BEFORE THE PLANNING COMMISSION
FOR THE CITY OF WEST LINN, OREGON

In the Matter of WEST LINN-WILSONVILLE) FILE NOS: CUP-15-03, DR-15-17, and
SCHOOL DISTRICT 3JT's Application for) VAR-15-01/02/03
Conditional Use, Design Review, Director's)
Exception, and Class II Variance Approval to) SAVE OUR SUNSET PARK'S
allow construction of a new primary school) SUPPLEMENTAL MEMORANDUM IN
and related facilities in the R-10 zone.) OPPOSITION

RE: File CUP-15-03/DR-15-17/VAR-15-01/02/03. Response to March 28, 2016
comments by Mark Wharry, P.E. at KPFF

Figure 1. Site Location Map and Shallow Landslide Risk

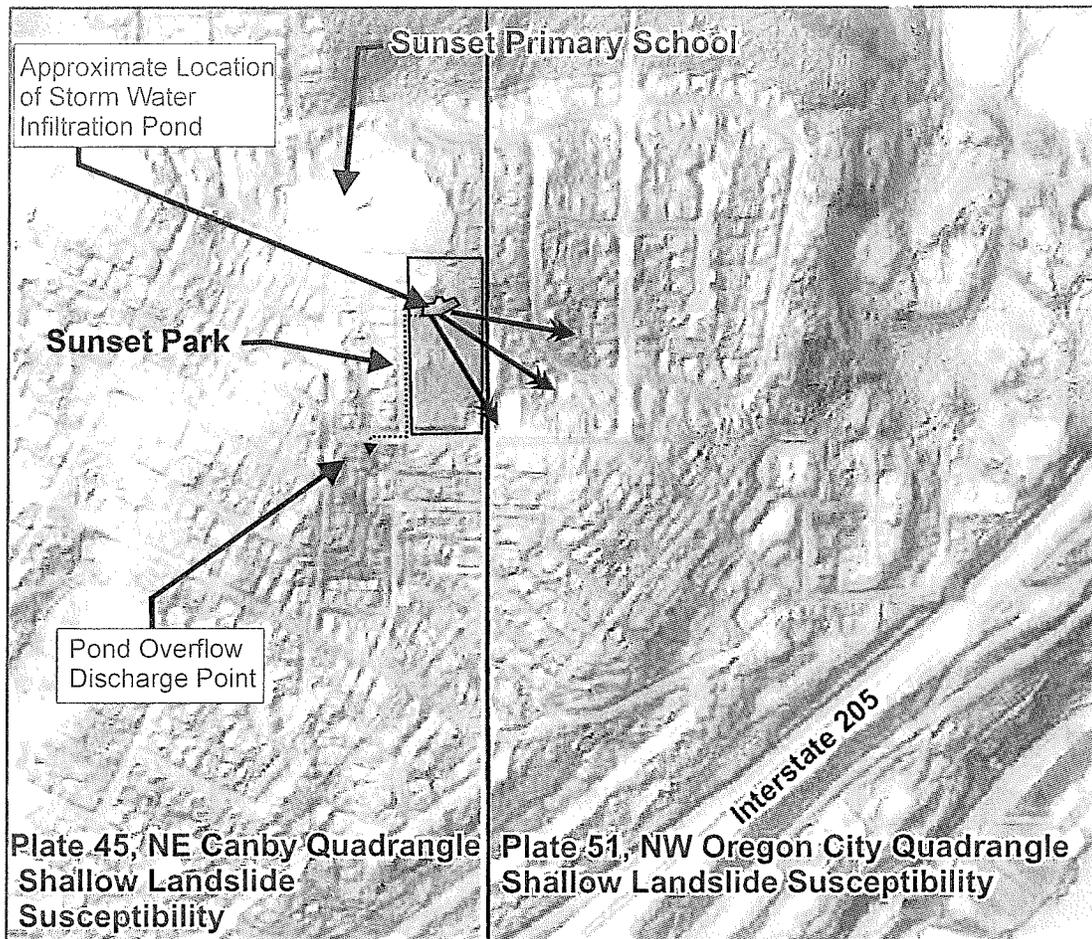
- In their summary of testimony (summary statement No. 5), KPFF states there is no evidence to support the conclusion that the proposed facility could trigger landslides or reactivate existing landslides. The landslide hazard maps prepared by Department of Geology and Mineral Industries (DOGAMI) are evidence that there is the potential for landslides.
- Storm water examples given by KPFF are not applicable here. The proposed facility will be constructed on top of a hill with a relatively shallow depth to bedrock, which makes the area more prone to landslides.

In summary, our concerns about the increased risk of landslides and flooding for neighboring properties still remain. The proposed changes do not fully address those issues.
